# MY1 (2022) FINAL MONITORING REPORT

## Bull Chute Stream and Riparian Wetland Mitigation Site

DMS Project ID No. 100137  
Full Delivery Contract No. 7878-01  
RFP #16-007878 (Issued: 5/6/2019)  
USACE Action ID No. SAW-2020-00049  
DWR Project No. 20200021

## Responses to DMS Comment letter (dated January 4, 2023)

# Bull Chute Groundwater Gauge 4 Year 1 (2022 Data)

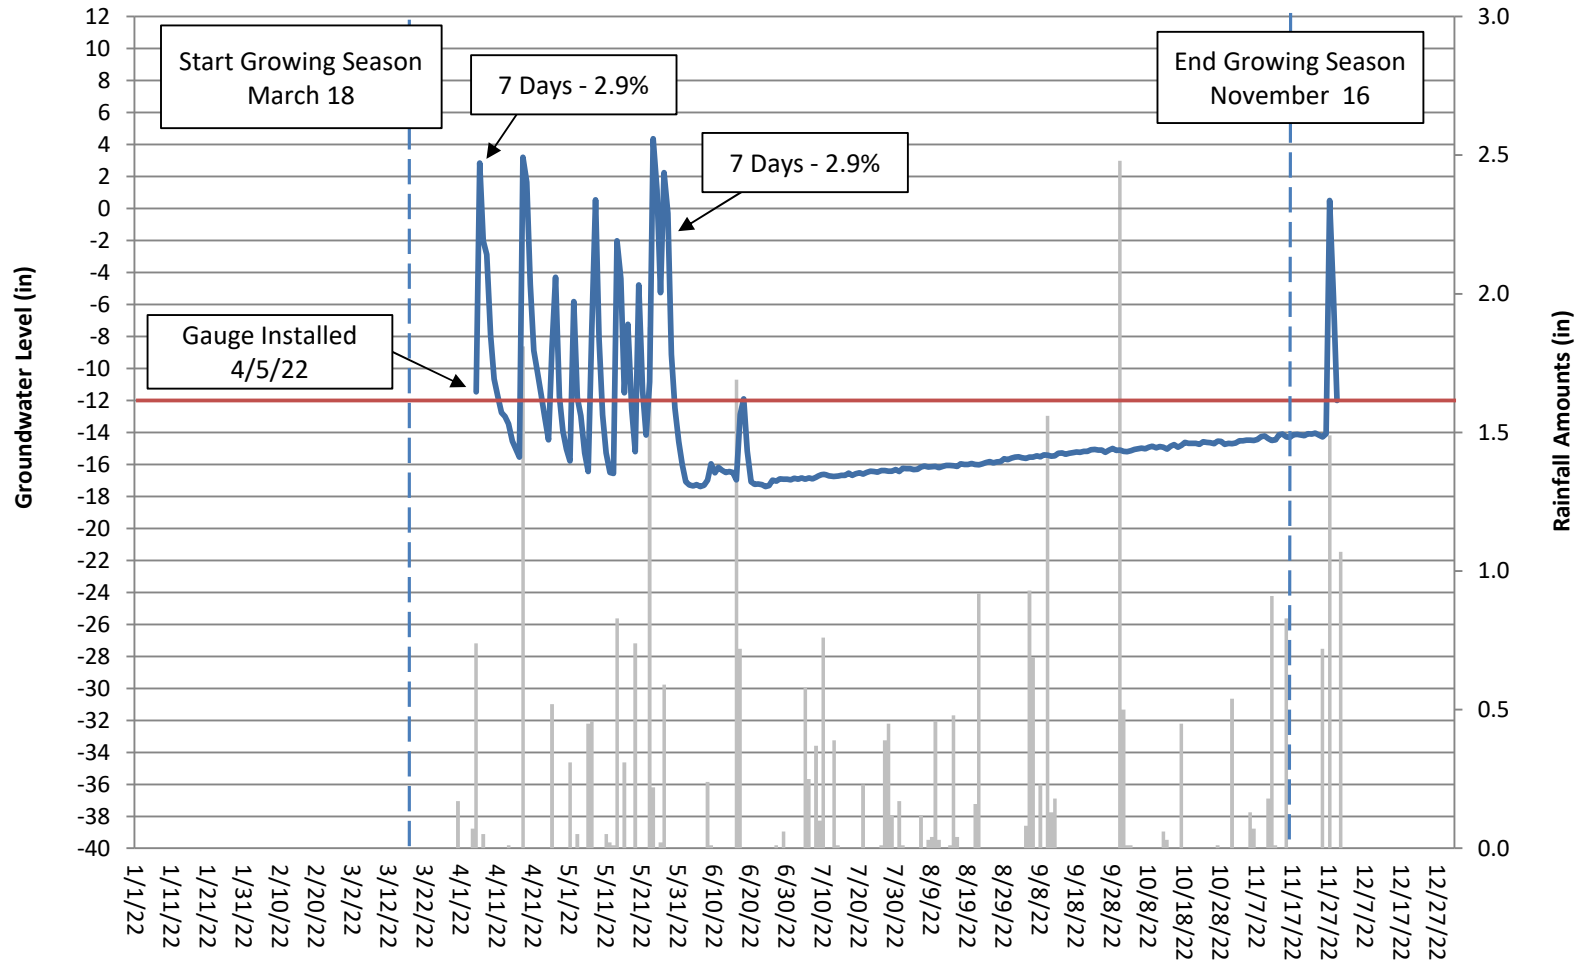
- Groundwater Gauge 4 Graph: Suggest revising Graph 4, the label of '7 days' is confusing in that it indicates a time frame greater than 7 days by calling out two 7-day periods. Please revise for clarity.  
[The gauge 4 graph was edited to show two separate callout boxes with two separate arrows. This should clarify that two separate 7-day periods occurred.](#)
